MEMO

To: Board of Adjustments

Re: Kyle Multi-family Community Parking Variance

Re: Friends of the Library Thrift Store- sidewalk variance

SITE PLAN sc: 1" = 10' - 0"

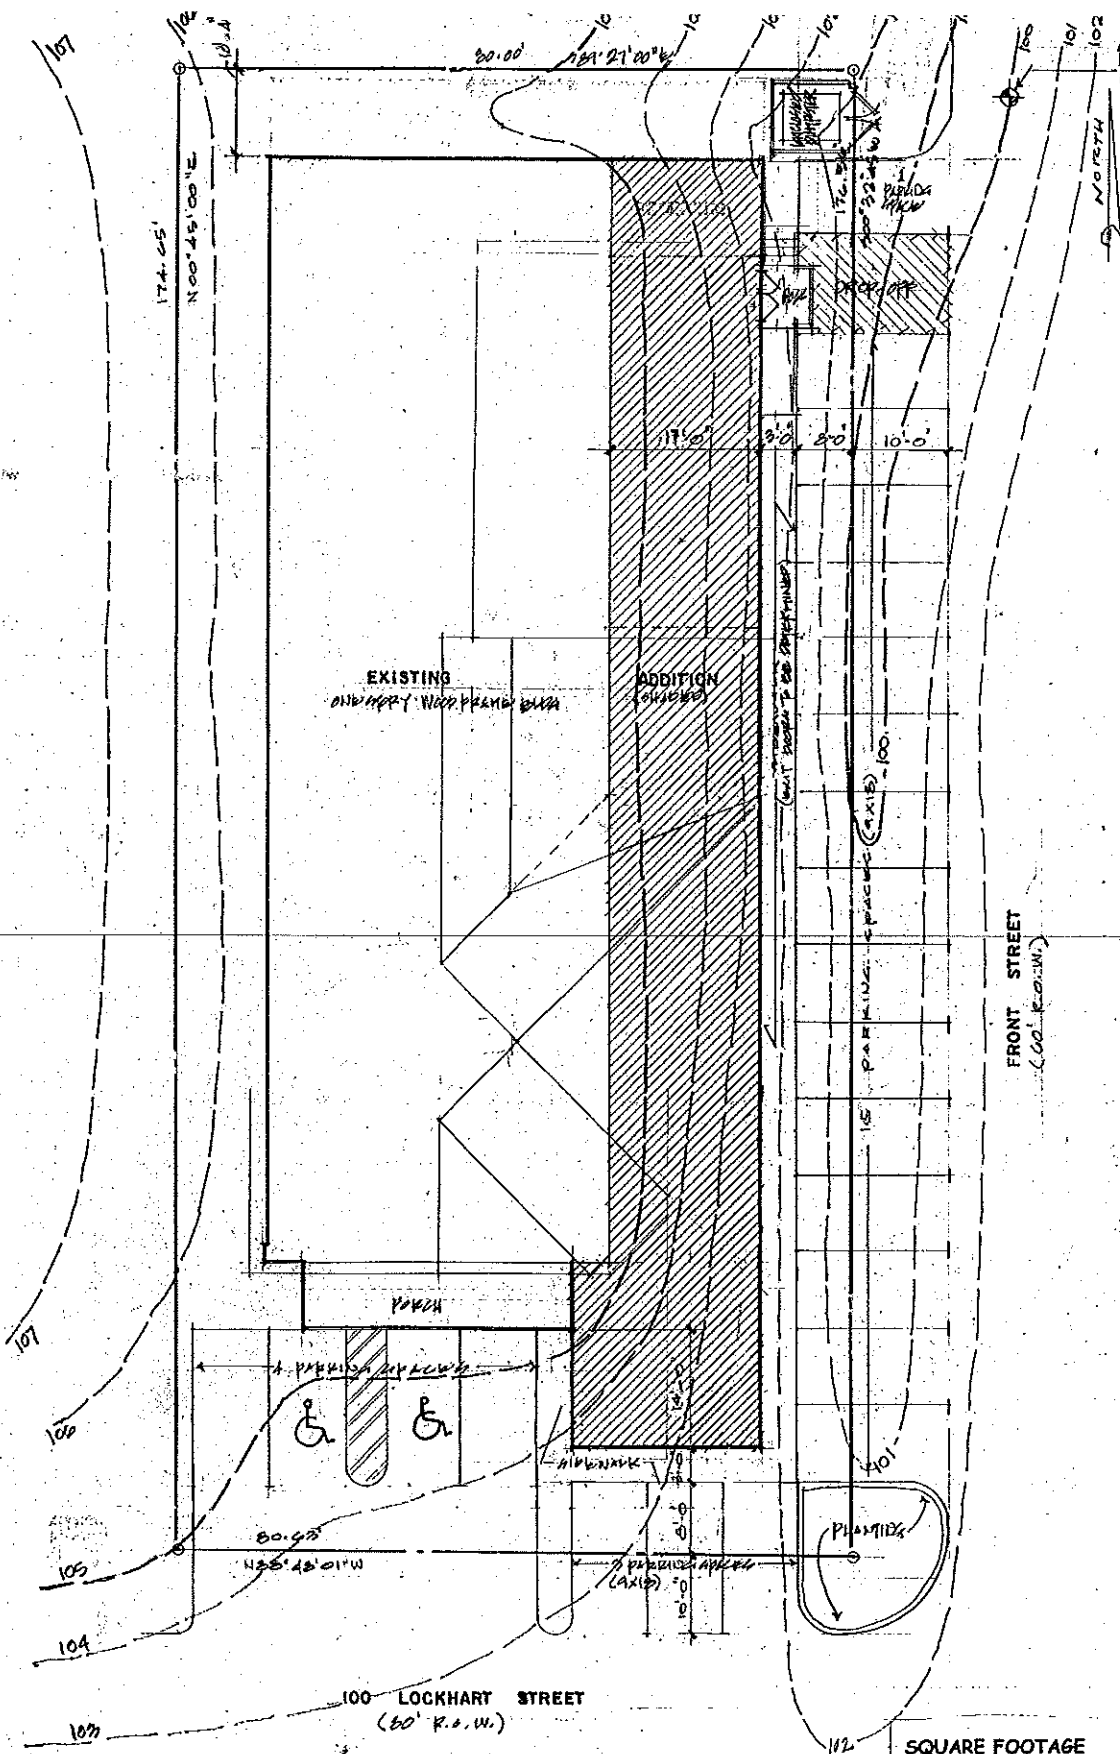
- The subject property is zoned Central Business District 2 (CBD-2). The stated intent of the zoning district and the requirements of the district are to address development in the original town and central area of the city, allowing a mix of uses including, office, restricted commercial, restricted multi-family residential and residential uses. As new development is constructed and existing sites are redeveloped the expansion of sidewalk connectivity is crucial in meeting the intent of the ordinance and in order for the spirit of the CBD2 district to be observed.

- It appears that the literal enforcement of the ordinance would result in a decrease number of parking spaces available to the development; however it does not appear that there are special conditions unique to this property that the literal enforcement of the ordinance would result in unnecessary hardship or inequity for the petitioner.
- Should the variance be approved and the property owner is not required to construct a sidewalk across either street frontage a gap in sidewalk connectivity would be created when the adjacent properties are redeveloped and are required to install sidewalks. Though the redevelopment of the property to the north and the city financing of a sidewalk across the water tower site may be many years away the loss in sidewalk construction on the subject property could cause lasting sidewalk connectivity issues.

This project does not change access to the perimeter streets and does not include City or private sidewalks on the property perimeter. This is not typical "new construction" but only an addition to an existing structure. An internal sidewalk along the east frontage of the building, to provide improved pedestrian access from the parking area to the main entrance, is contemplated.
